From: Gray, William E
Sent: Thursday, September 19, 2024 11:18 AM
To: Bobby Hill
Subject: PRE-24-0922, Westside Service Bar, 812 S Sierra Madre

Request – Add a covered service bar in the west yard area of Trainwreck adjacent to W Las Animas St.

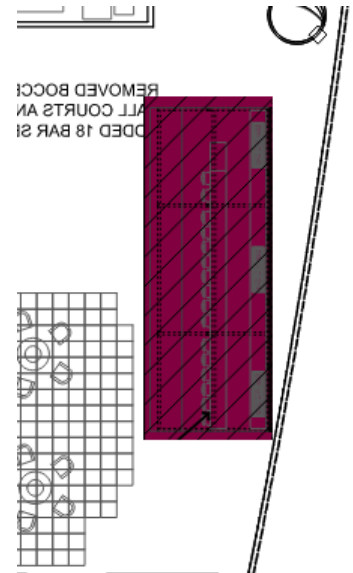
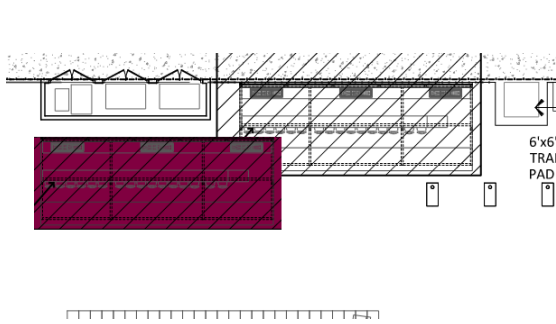
- 8) One concern with the proposal is street loses some of its pedestrian friendliness along Las Animas St. Street frontage will have back of the new bar and trash enclosure. Lose the open view into the active west yard, which provides a pedestrian-friendliness and visual interest to the street. Both of these are required characteristics for street frontage in the FBZ.

- 9) Recommend site bar in alignment with Trash enclosure or relocate to west property line (see illustration below) to maintain the currently pedestrian friendly and more visually interesting street frontage to the open and active west yard of Trainwreck.
